# Armour Garments Ltd. Envoy Garments Ltd.

380/31/1 East Rampura, Dhaka-121.  
(23.763602, 90.423651)

3<sup>rd</sup> February 2015

# Observations

# Toilets Located in North side cantilever portion

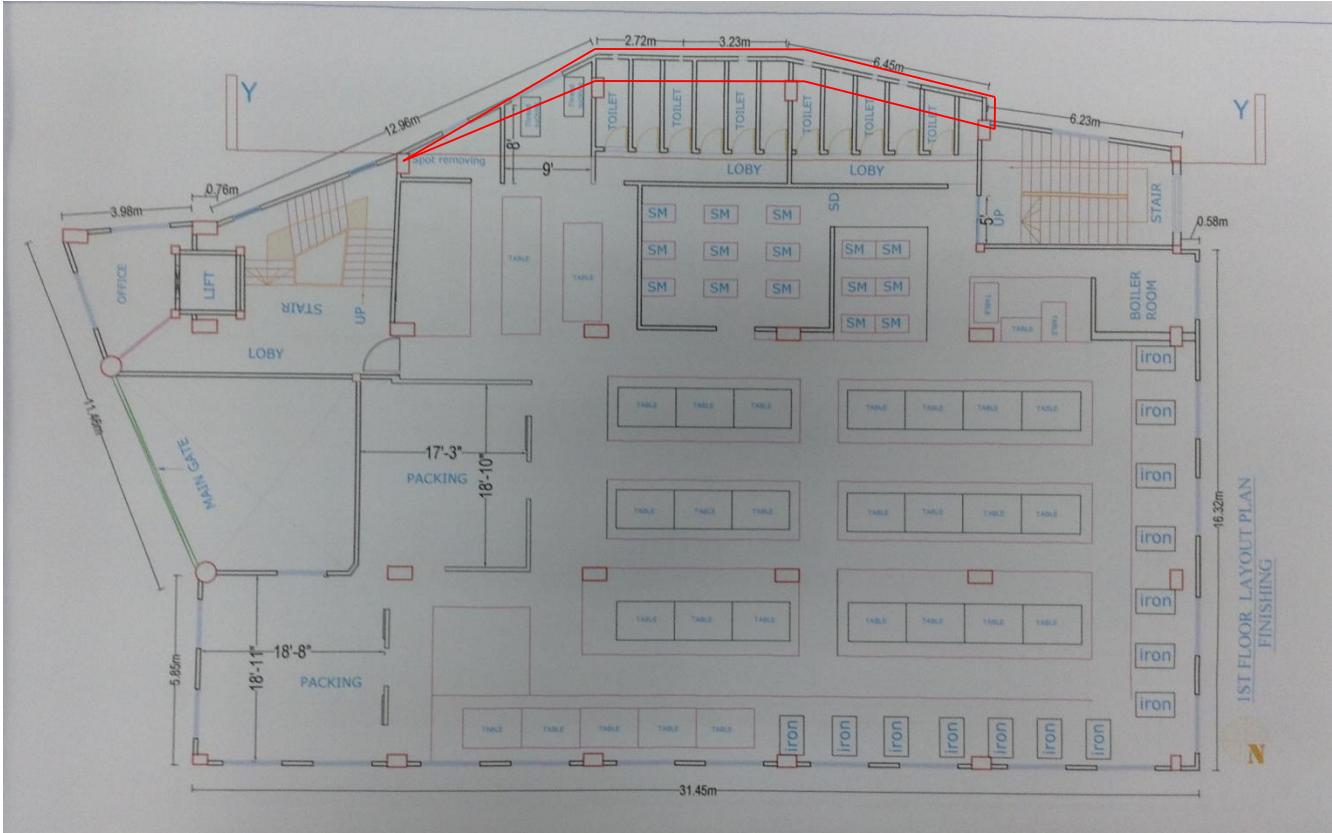
**ITEM 3:** Significant build-up in toilets

| Item No. | Observation  | Recommended Action Plan   | Recommended Timeline |
|----------|--|---|----------------------|
| 3        | Significant build-up in toilets                                | Engineer to expand current slab structural calculation study to cover the toilet loading on the slab.     | 6-months             |

Column layout on Structural drawing

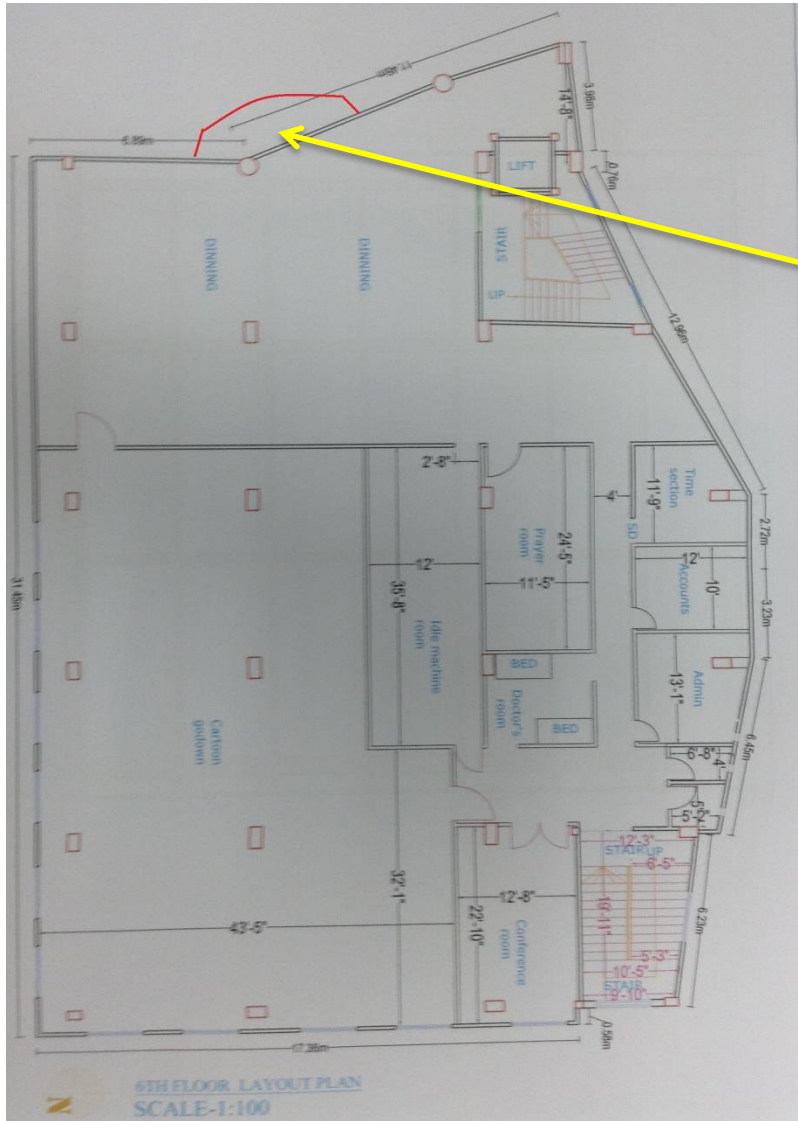
Rebar Fabrication found on site

16-20mm $\emptyset$  rebar found on site

16-25mm $\emptyset$  rebar found on site

**ITEM 1:** Different rebar noted on-site to the structural rebar drawings

| Item No. | Observation  | Recommended Action Plan   | Recommended Timeline |
|----------|--|---|----------------------|
| 1        | Different rebar noted on-site to the structural rebar drawings | Engineer to revise engineering drawings to reflect correct rebar.   | 6-months             |
